Subject: CERTIFICATE OF COMPLIANCE NO. 9292 FOR THE MODEL NO. PATRIOT PACKAGE: Follow-up Information Requested during Conference Call Held June 2, 2005 - DOCKET No. 71-9292; TAC No. L23770

Enclosure 1: Response to Follow-up Questions

Application for Certificate of Compliance for the Patriot BWR Fuel Shipping Package

Figure 1 USLs for 49 LWR-type fuel critical experiments, k_{eff} vs AEF (0.0 – 0.5 eV)

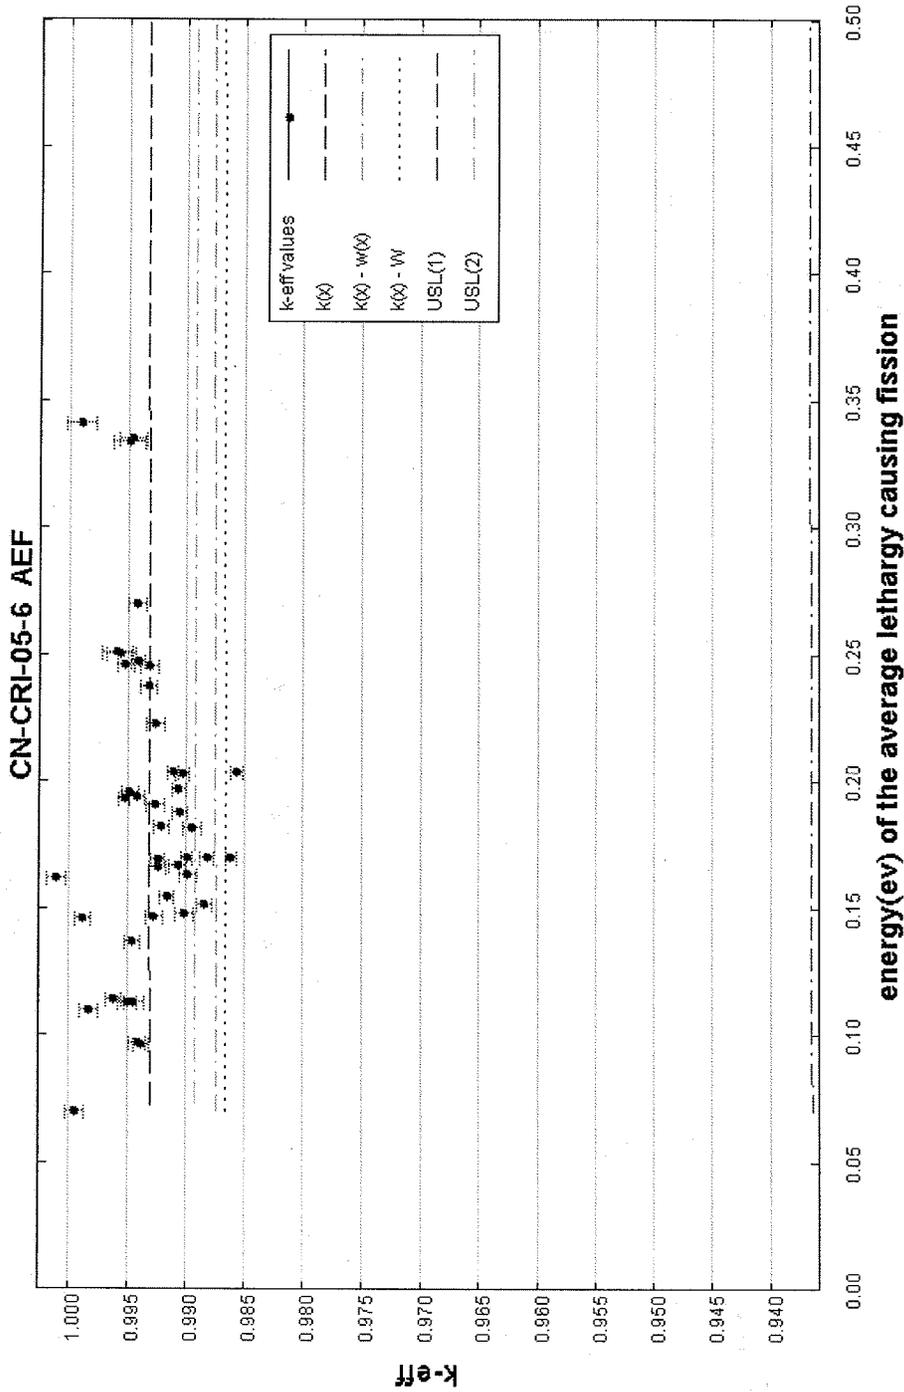
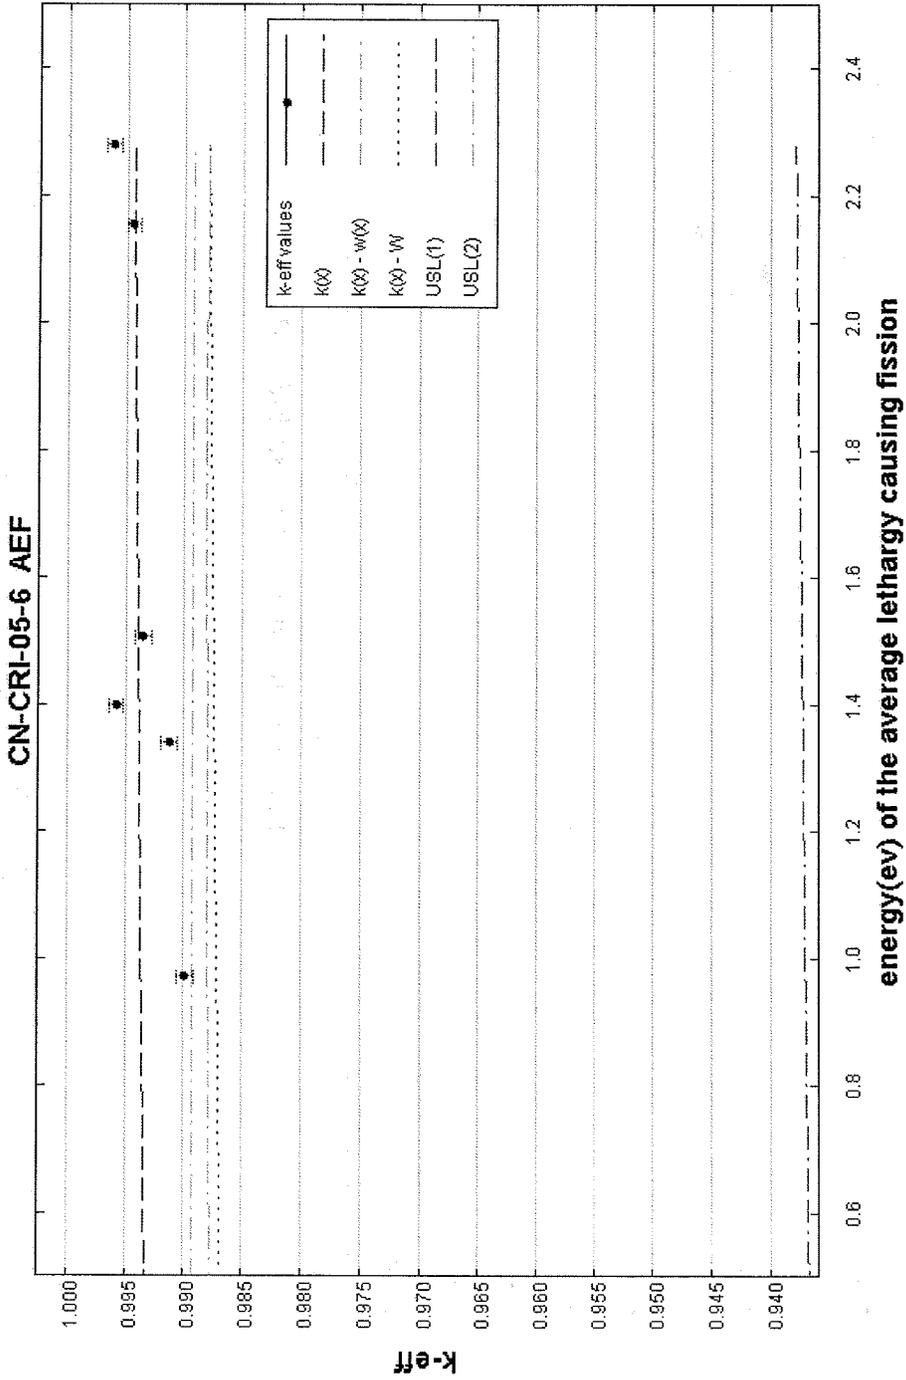
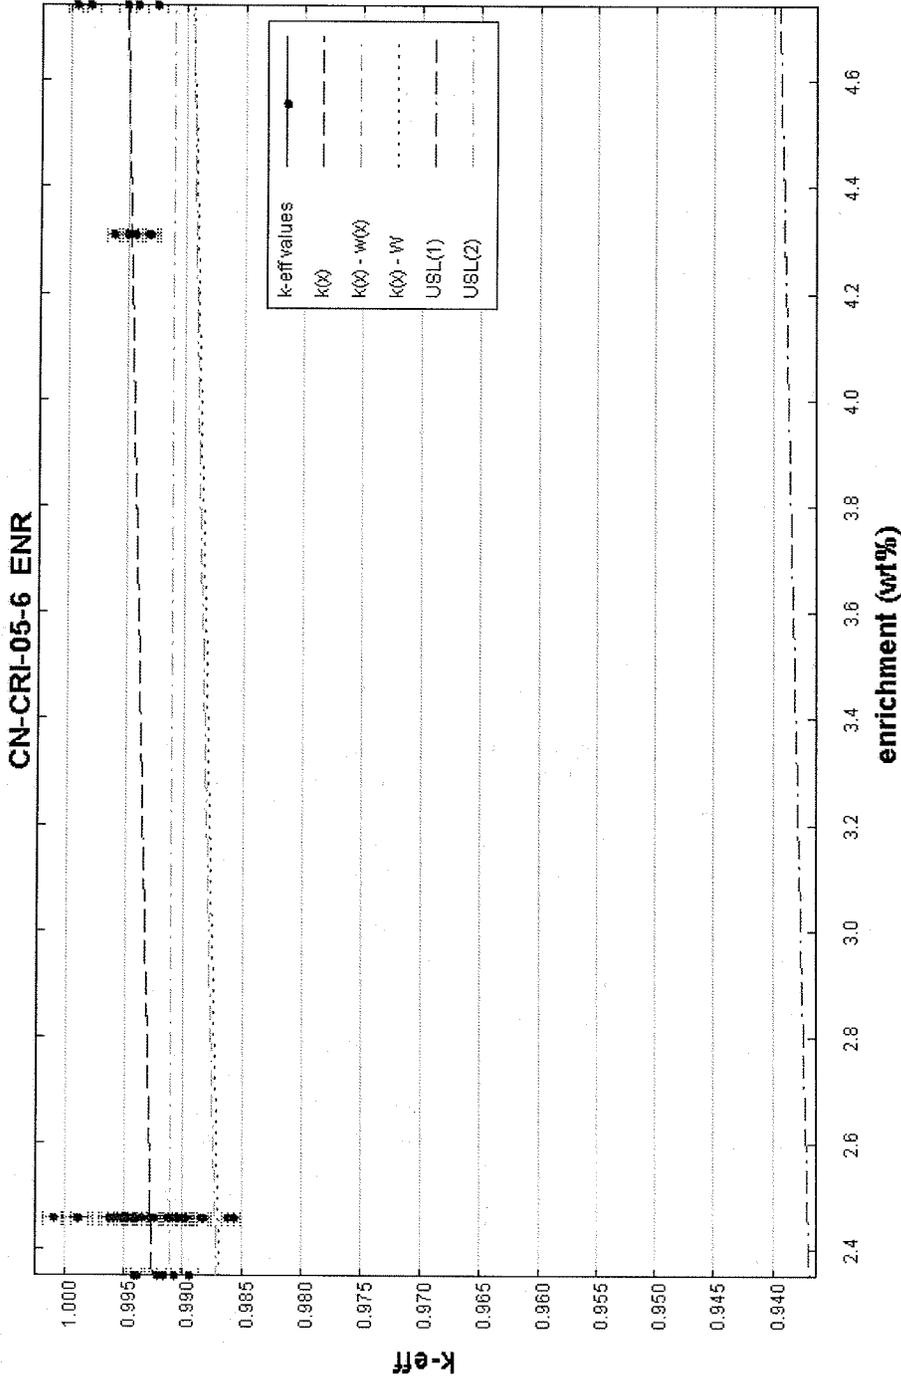
Provide trend data to substantiate these statements.

The USLSTATS output for AEF and ENR are provided to address the items above. Further, the data are graphed as follows:

- USLs for 49 LWR-type fuel critical experiments, k_{eff} vs AEF (0.0 – 0.5 eV),
- USLs for 49 LWR-type fuel critical experiments, k_{eff} vs AEF (0.5 - 2.5 ev), and
- USLs for 49 LWR-type fuel critical experiments, k_{eff} vs enrichment
